SITE PLAN REVIEW AND APPEARANCE BOARD STAFF REPORT

Meeting: January 9, 2019 File No.: 2018-013-SPM-SPR-CL3 Application Type: Delray Oasis Business Park

The action before the Board is the approval of a Class III Site Plan Modification application associated with building use conversions, expansion of parking lot, site improvements, and architectural elevation changes for the Delray Oasis Business Park project pursuant to LDR Section 2.4.5 (G)(1)(c), including the following:

Proposed Site Plan 1 = 20" Sc.

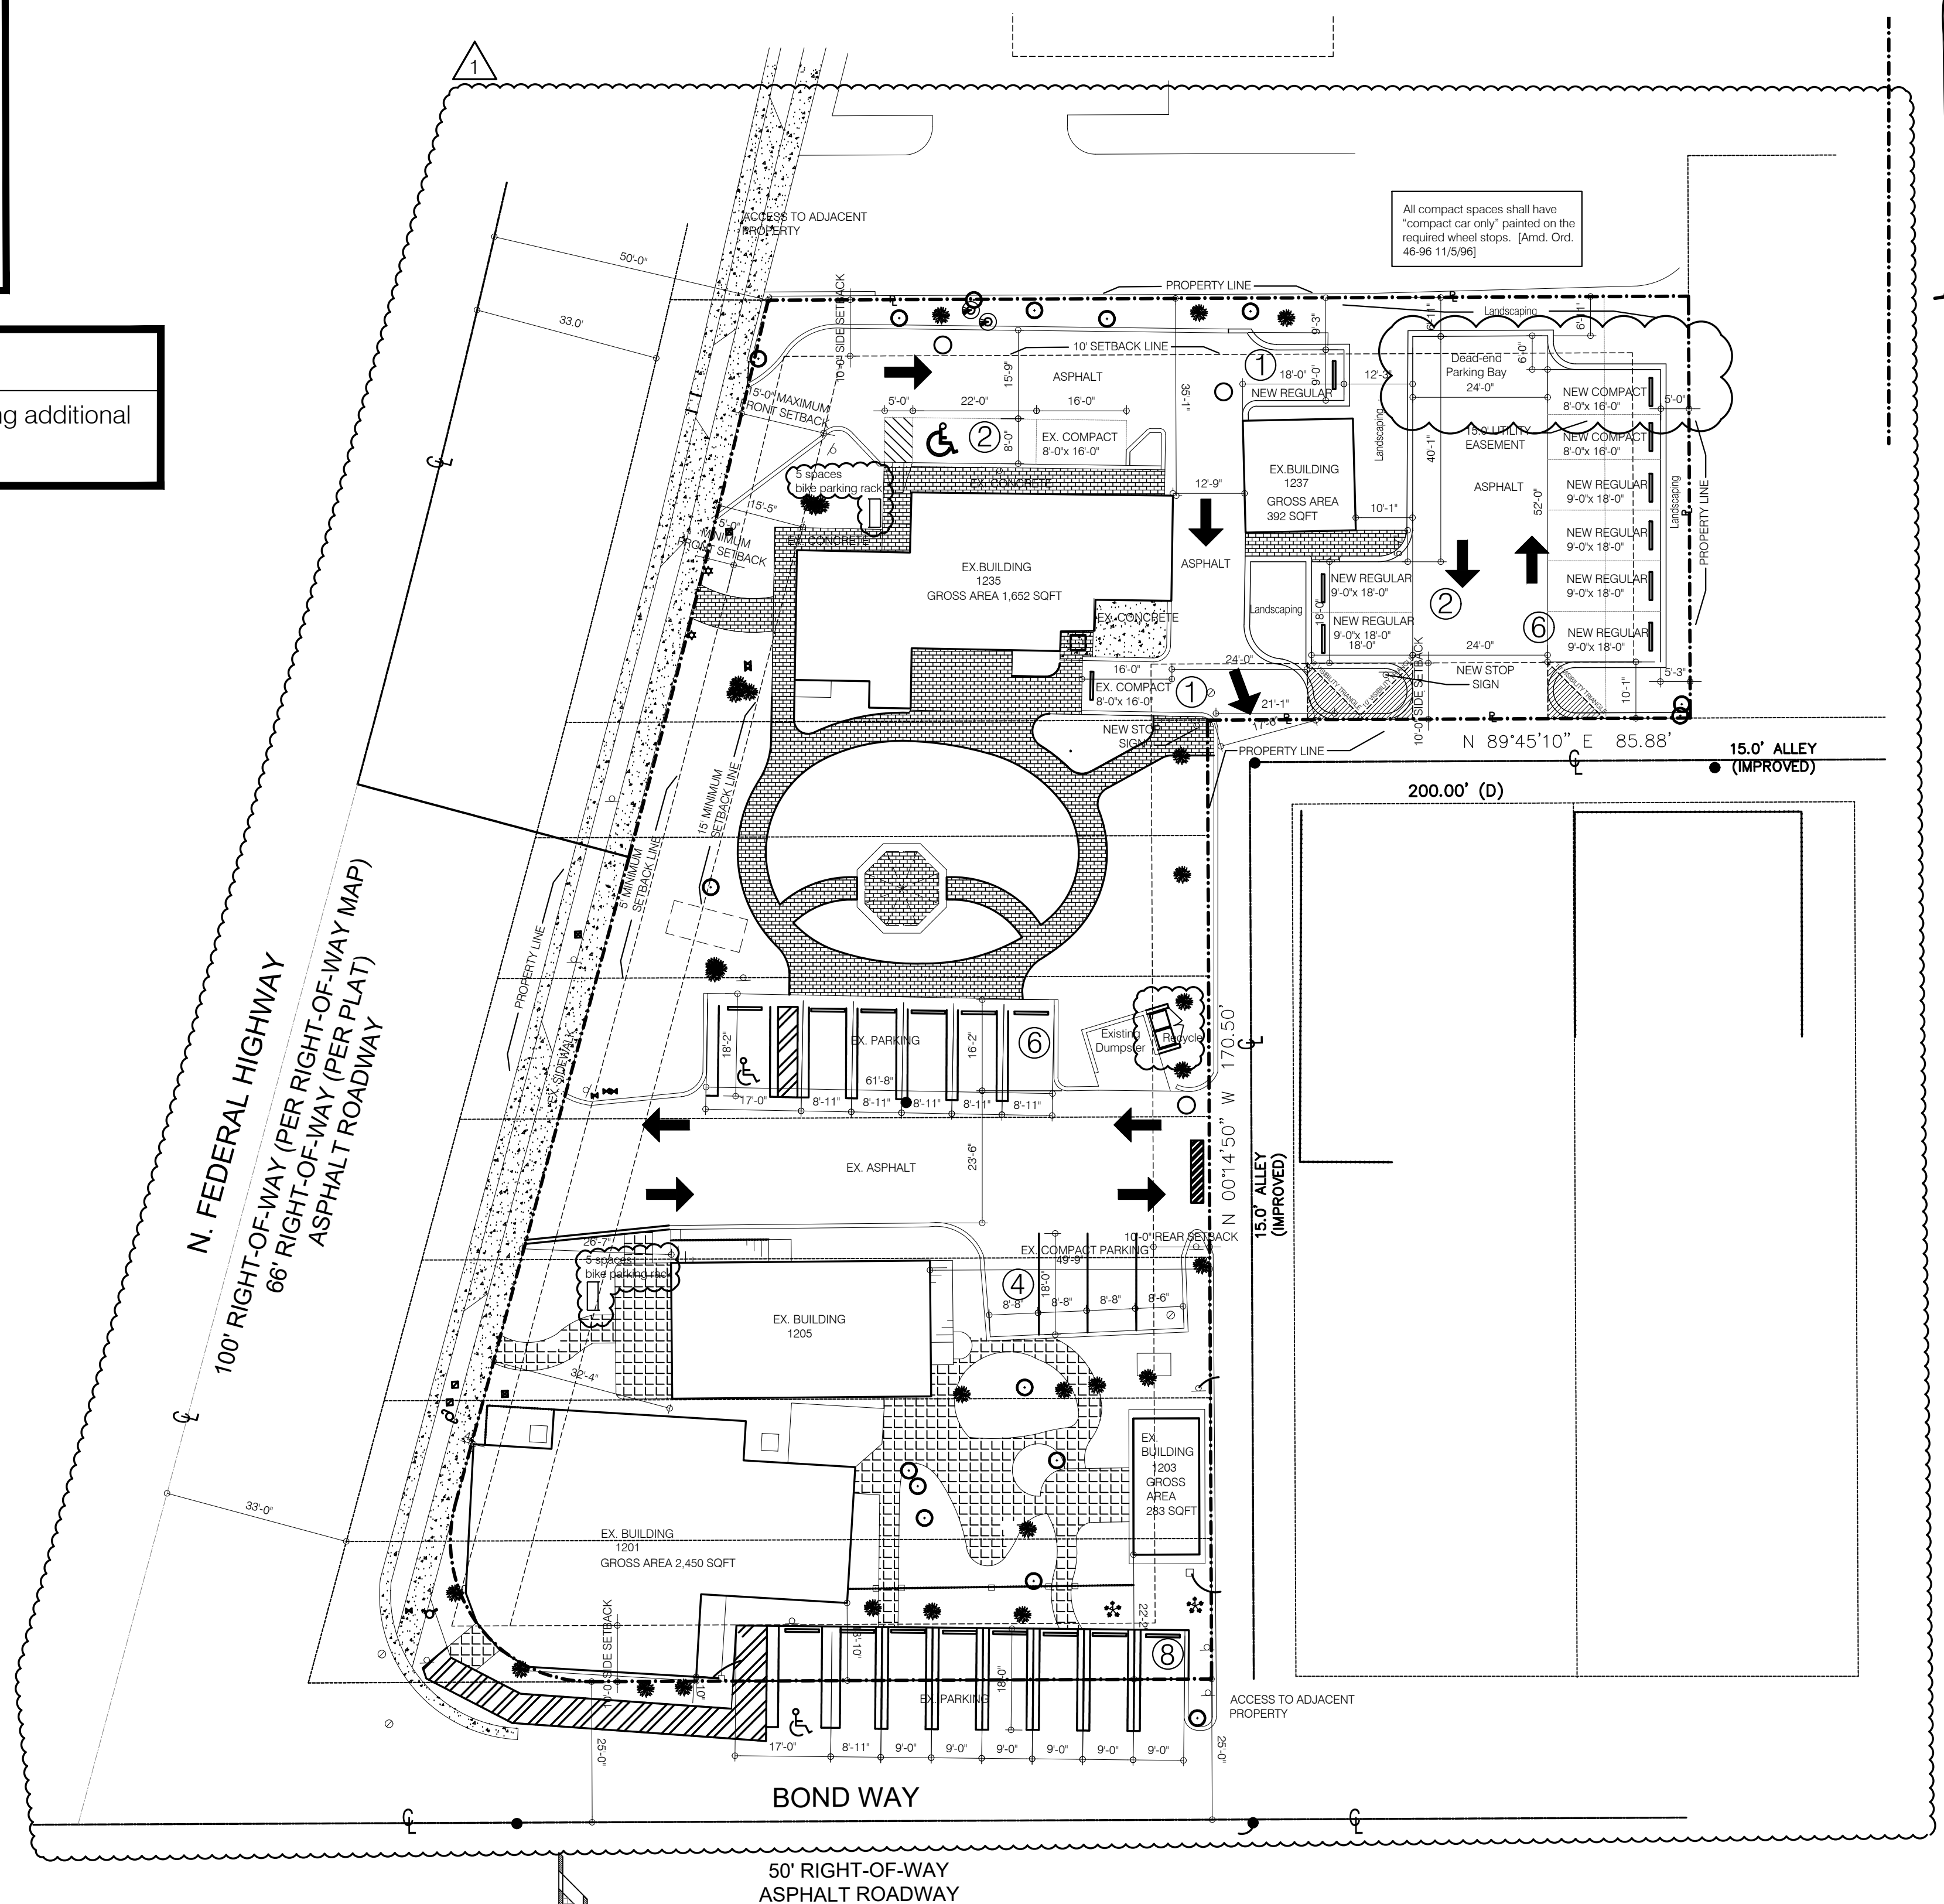
- ✓ According to site plan page SP1, the site has a total of 6,752 sf. of leasable space. It is indicated on the plans that 6,360 sf. of gross floor area will be designated for uses classified as General Commercial, and a total of 392 sf. will be designated for a Business and Professional Office. As the business office space does not share any common areas with other offices, the total gross floor area is subject to the parking requirements. The site is required to provide 30 spaces, as identified in the table below, and 30 spaces are provided throughout the development. Thus, the proposal meets this requirement.

- ✓ The subject site is already developed and is landlocked on three sides. A dead-end parking bay is proposed at the north end of the new parking lot to accommodate additional parking spaces. The proposed maneuvering area located at the end of the bay measures 24 ft. wide by 8 ft. deep; thus, this requirement is met.

Proposed Photometrics 1/8" Sc.

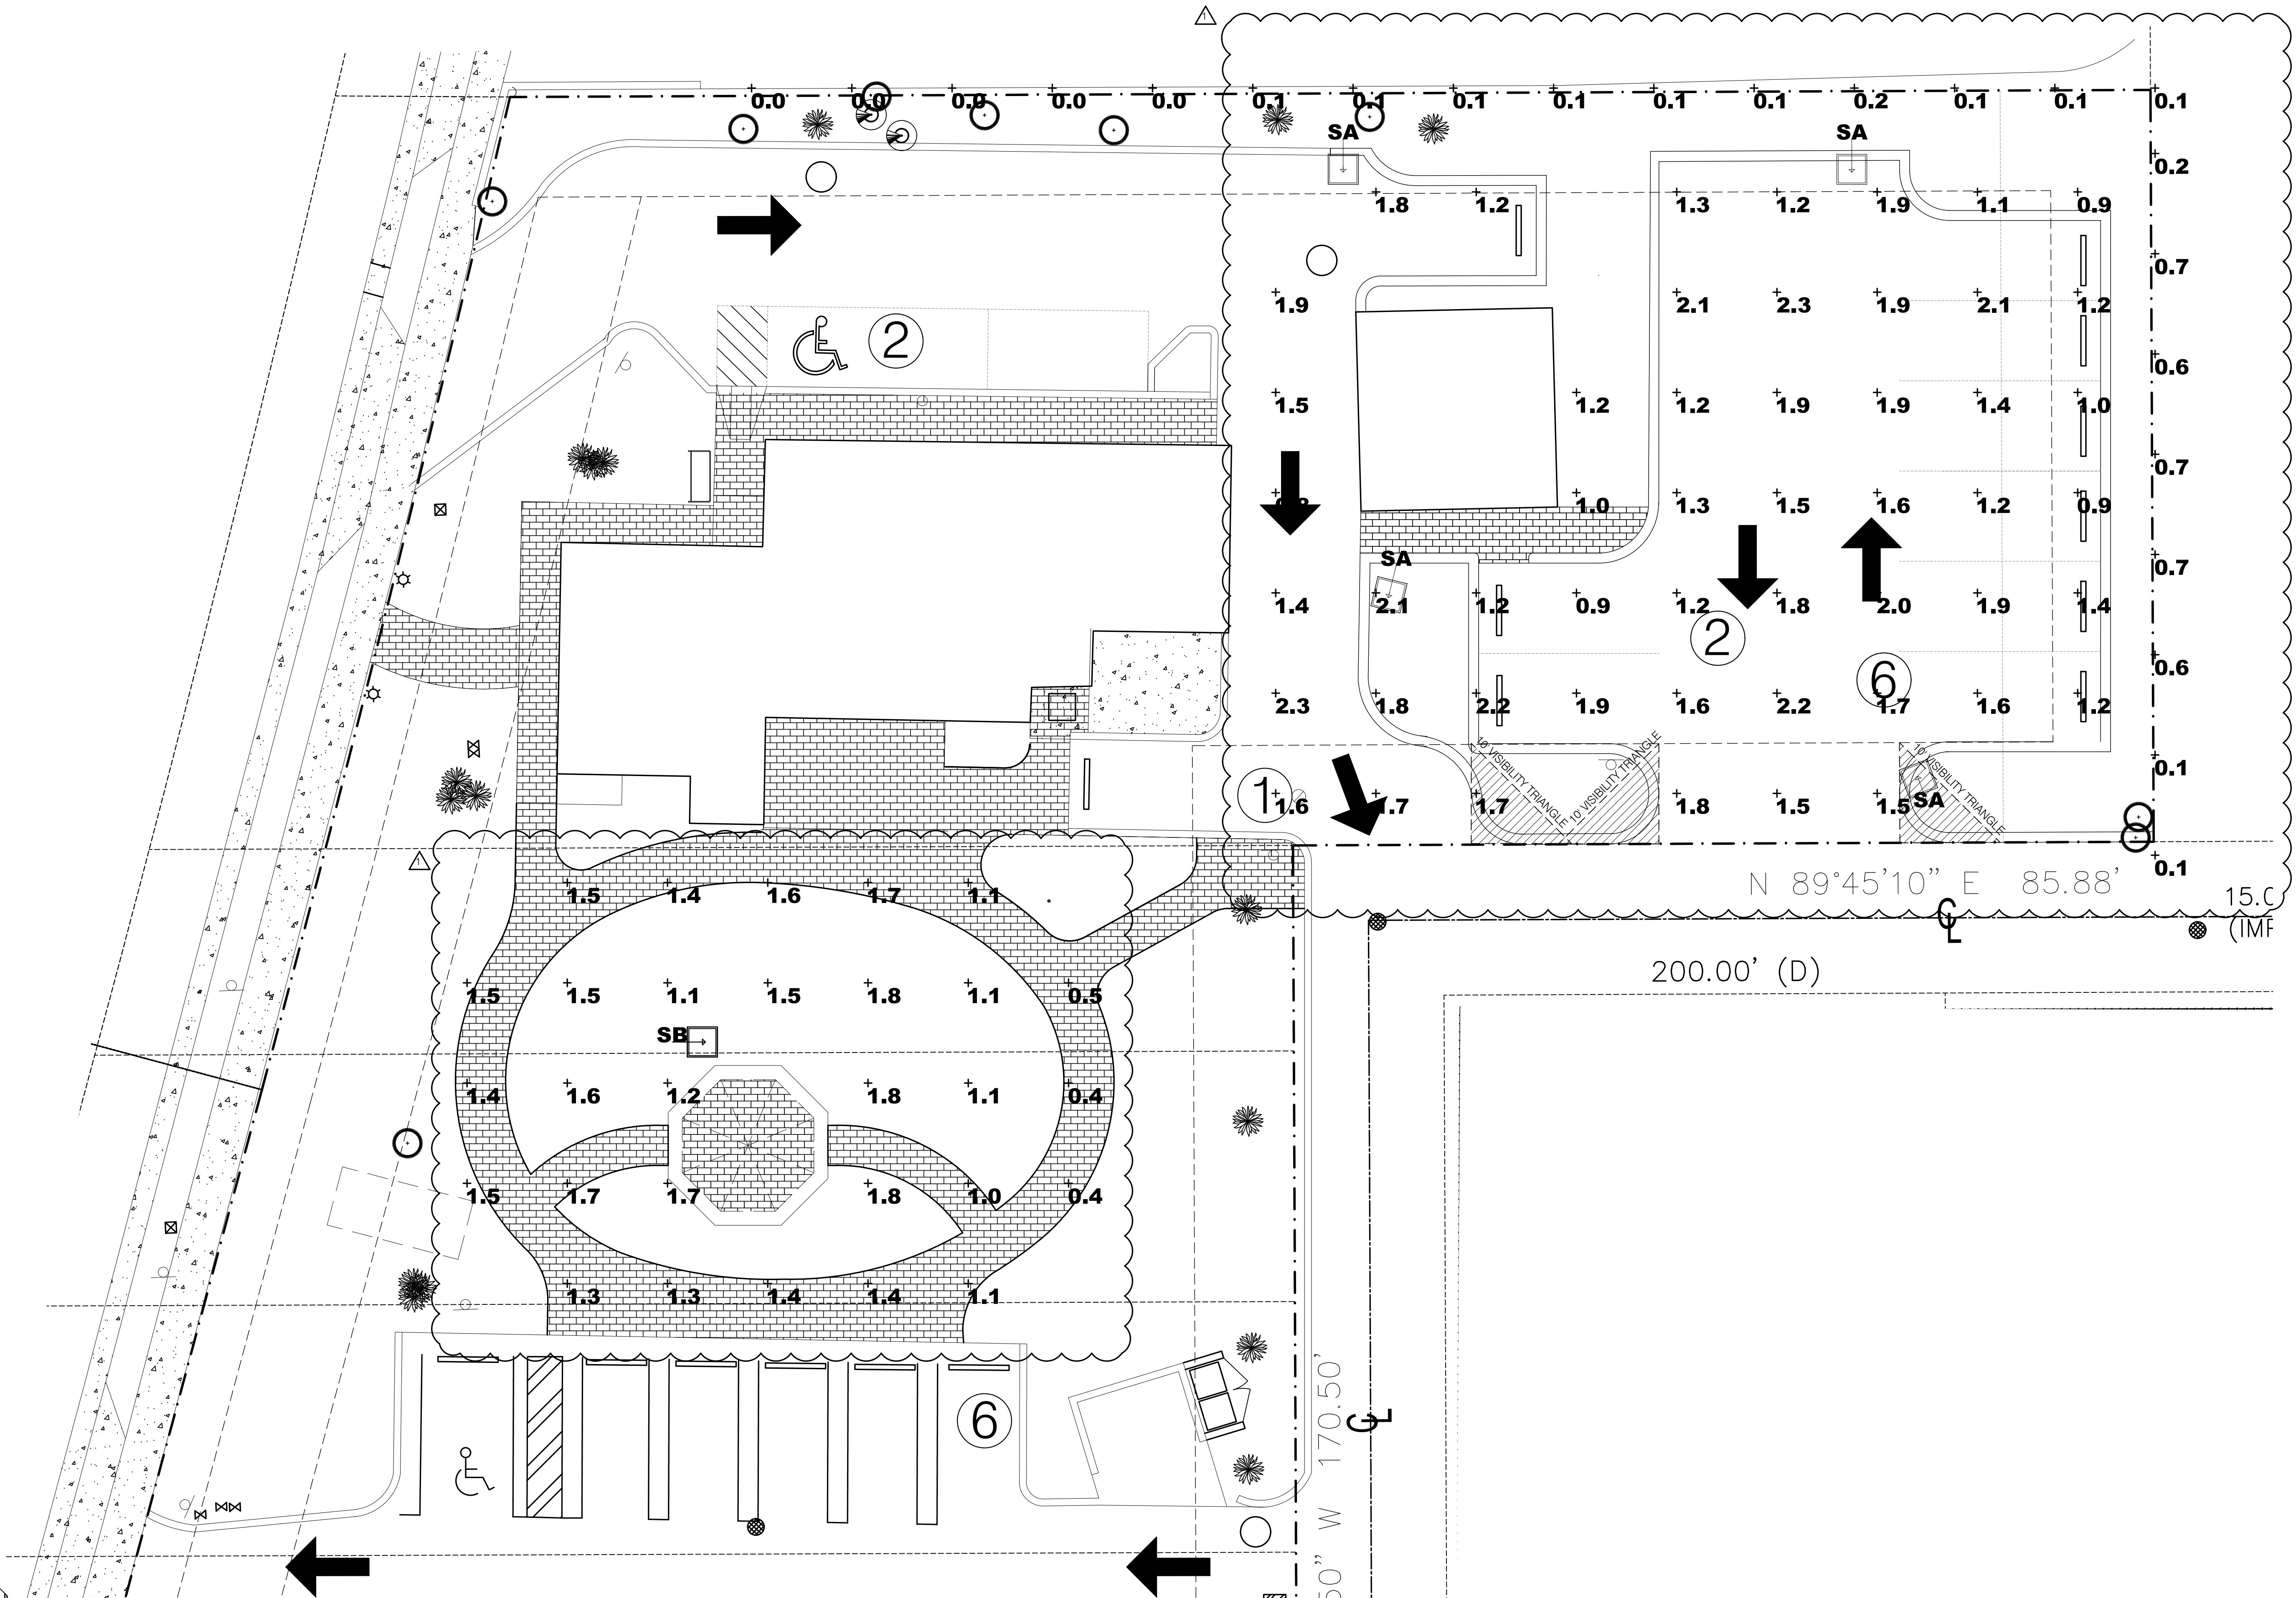
Photometric Plan	Requirements		Proposed		In Compliance
	Minimum (fc)	Maximum (fc)	Minimum (fc)	Maximum (fc)	
Parking Lot (Commercial)	1.0	12.0	0.8	2.4	No*
Building Entrance	1.0	10.0	10.0	9.7	Yes
Accent Pathway	0.5	5.0	0.7	1.9	Yes

- ✗ Listed as an outstanding requirement under notes section, the photometric plan shall be revised prior to site plan certification to meet the illumination levels for commercial parking lots as indicated in LDR Section 4.6.8.
